ADDENDUM NUMBER 1

- 1.01 DATE: April 7, 2015
- 1.02 PROJECT: Interior Renovations to the Mimosa - G Residence
Ramapo College of New Jersey
- 1.03 SNS PROJECT NUMBER: 4698G

INTERIOR RENOVATIONS
AT THE
MIMOSA - G RESIDENCE

Client

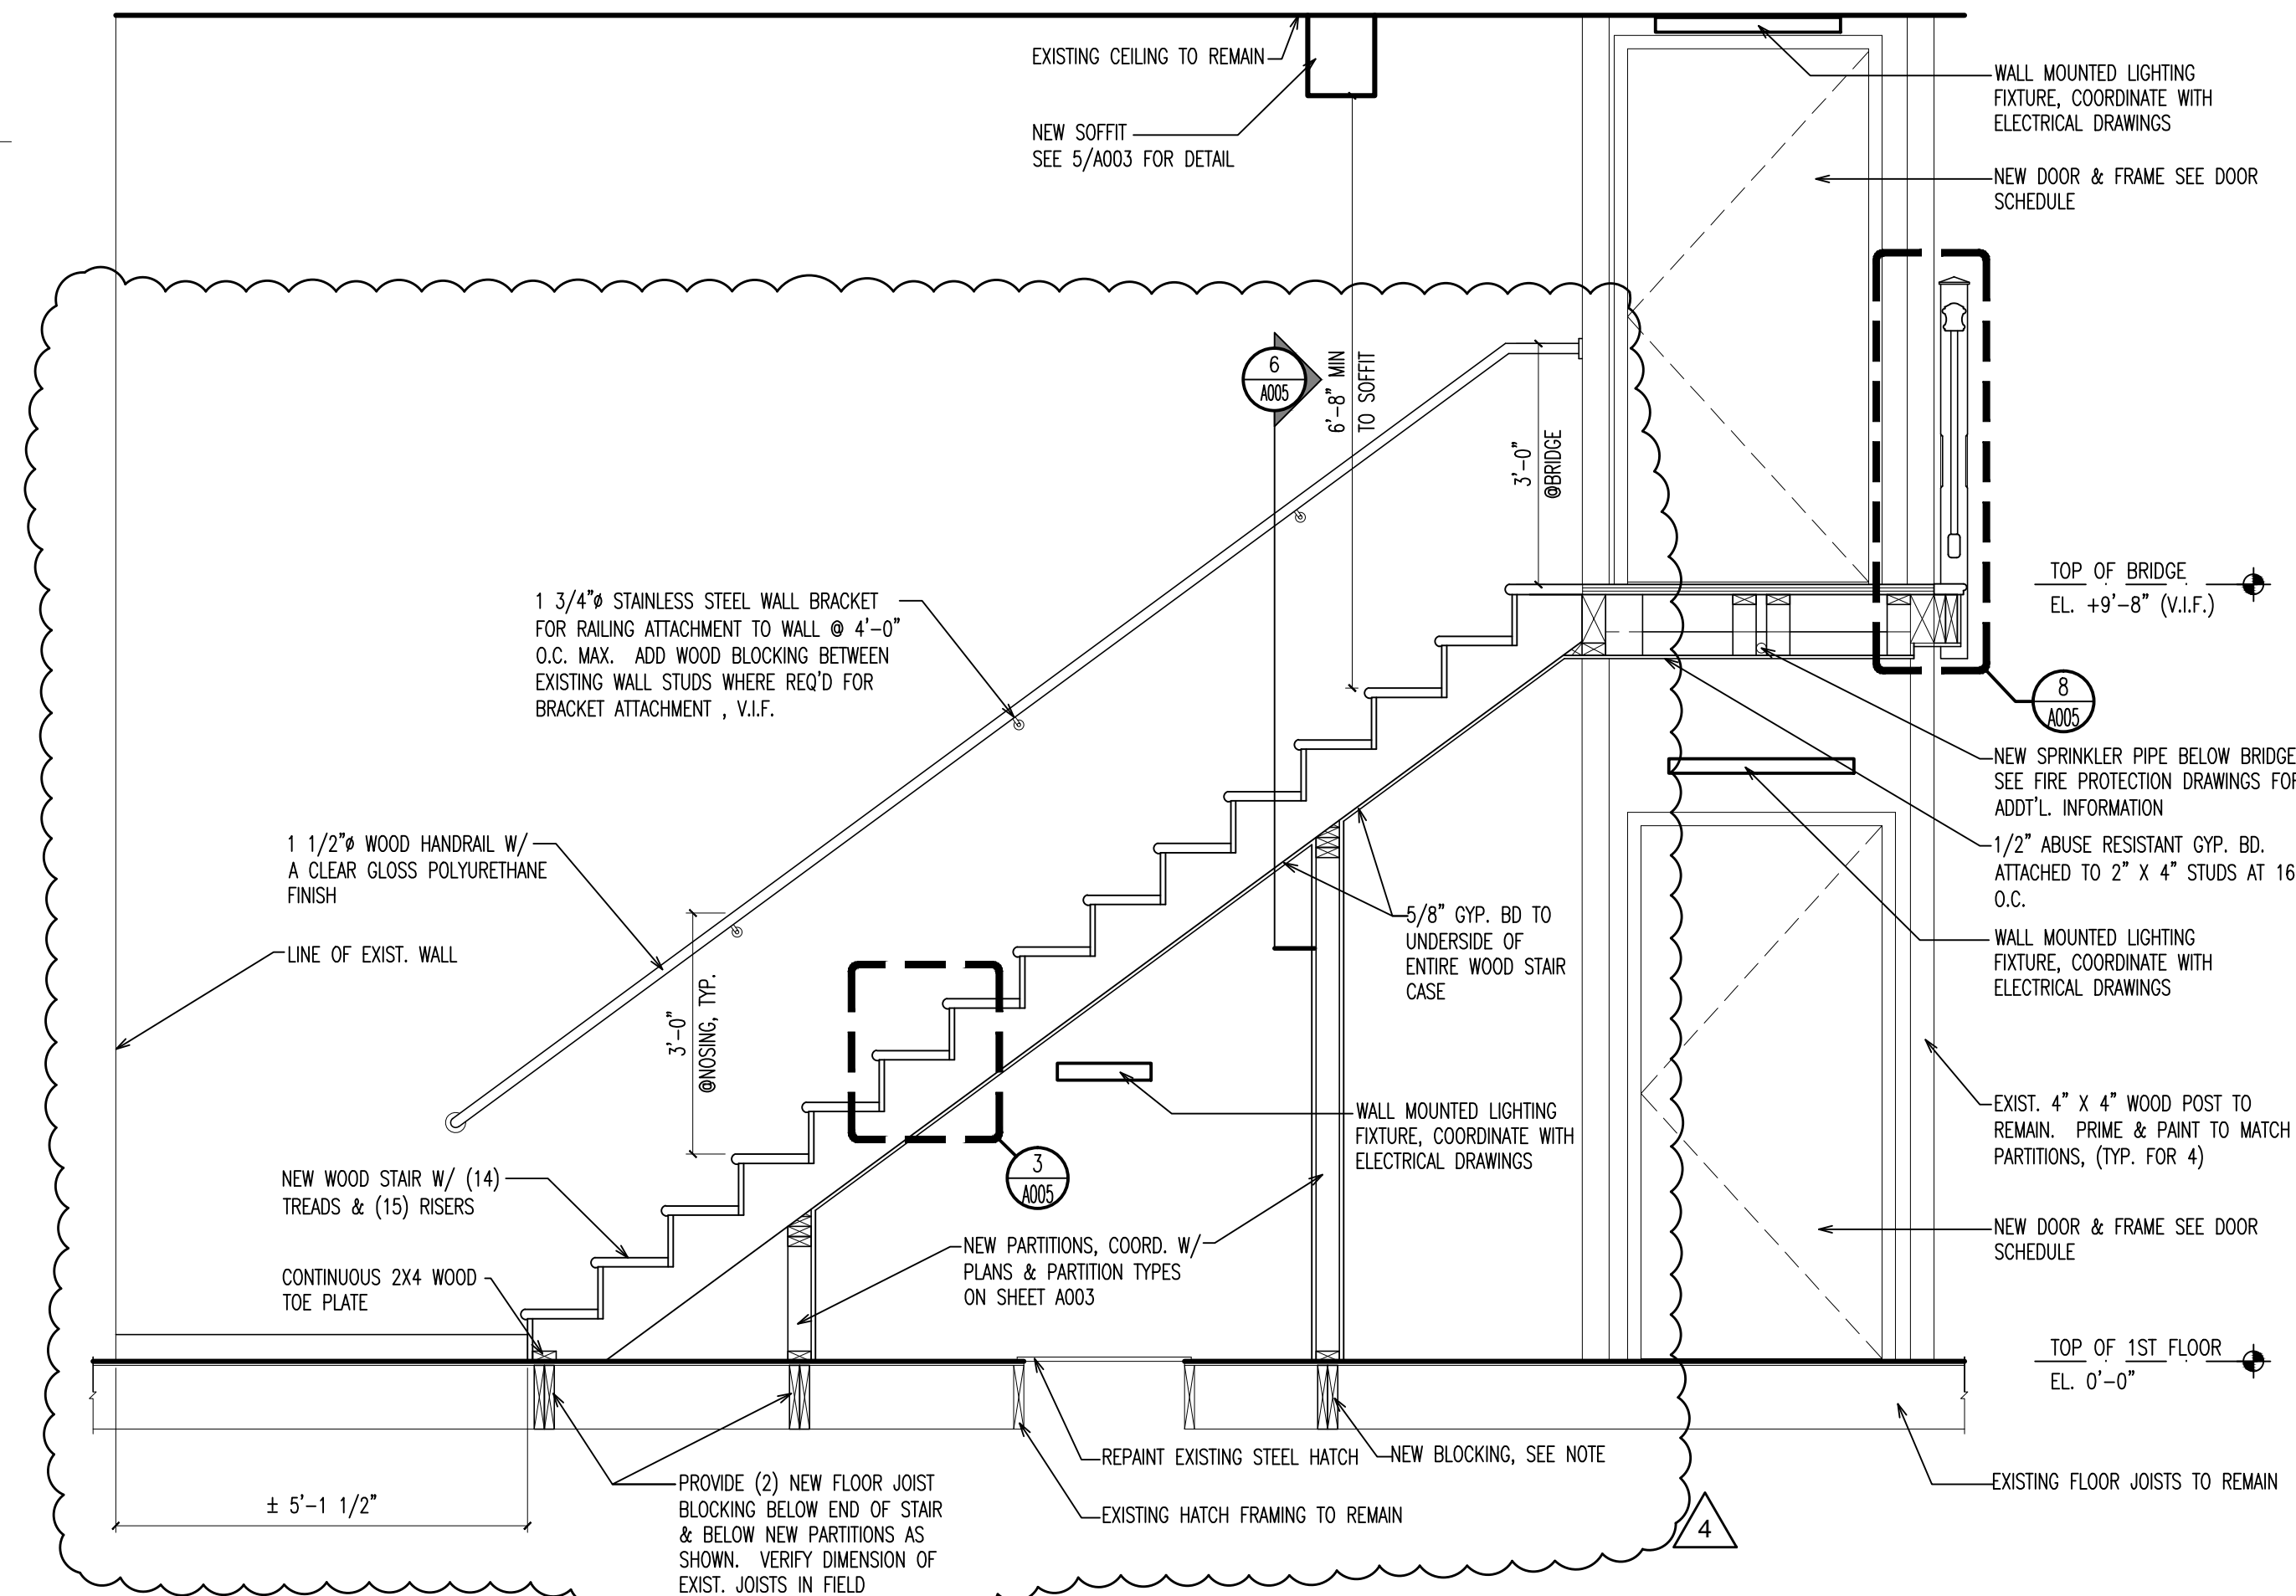
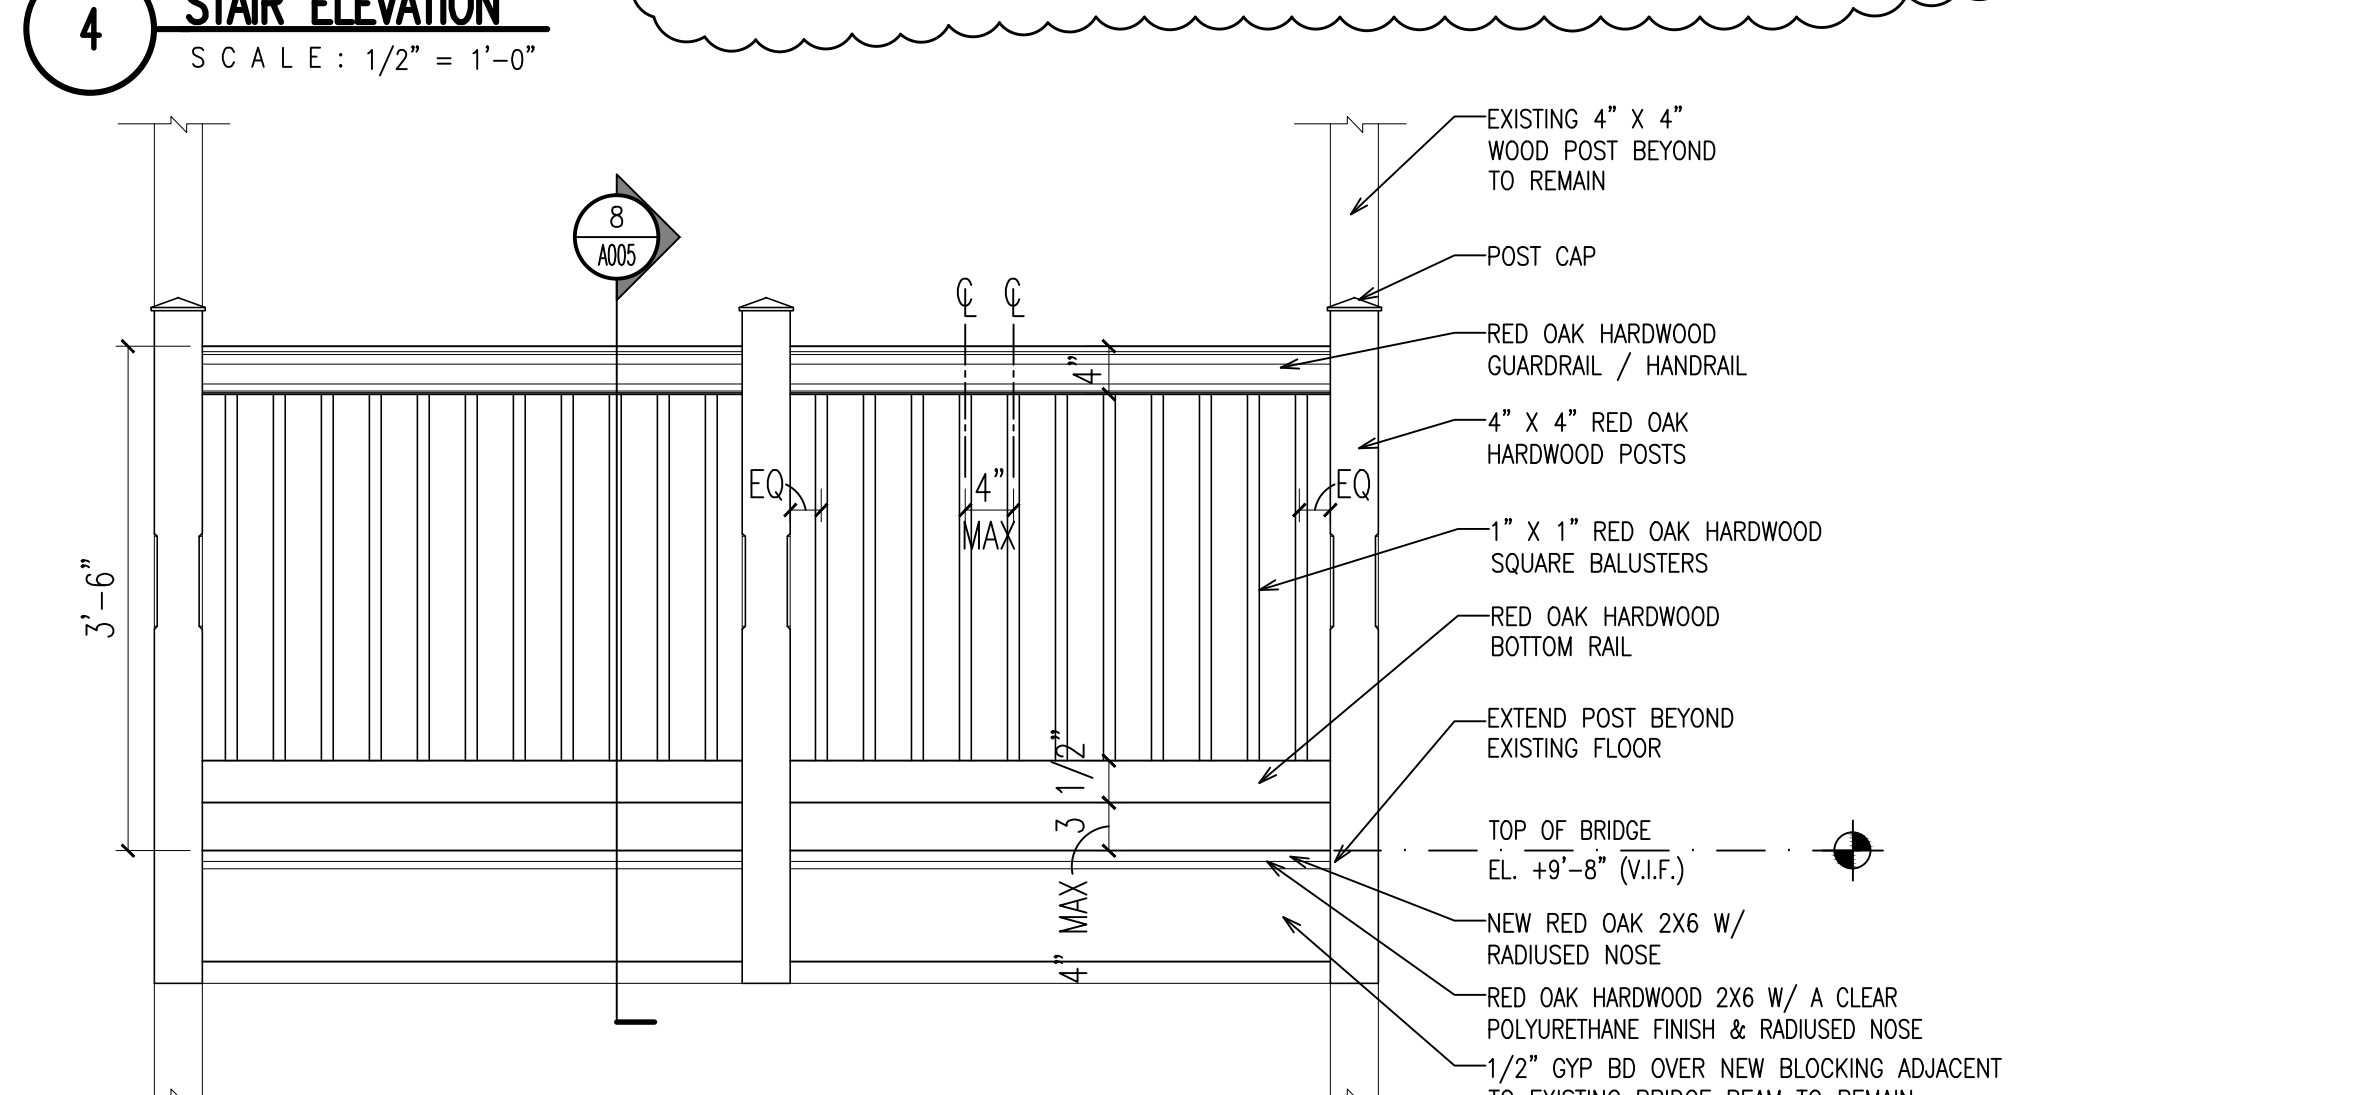
- 4.4. Insulation Notes: first note has been revised.
- 5. DRAWING A004, ENLARGED PLAN, MILLWORK, DETAILS & EQUIP. SCHEDULE:
 - 5.1. Equipment Schedule:

- 5.1.1. Mark & Description #29 have been removed (Vinyl Composite Tile Flooring).
 - 5.1.2. Mark #28, has been revised, it is no longer an alternate in kitchen area.

- 5.2. Enlarged Bathroom & Kitchen Plan: Mark #29 has been replaced with Mark #28.
 - 5.3. Cabinet Sections #7, #8 & Vanity Section #9: VCT finish flooring note has been replaced with” Linoleum finish flooring”.
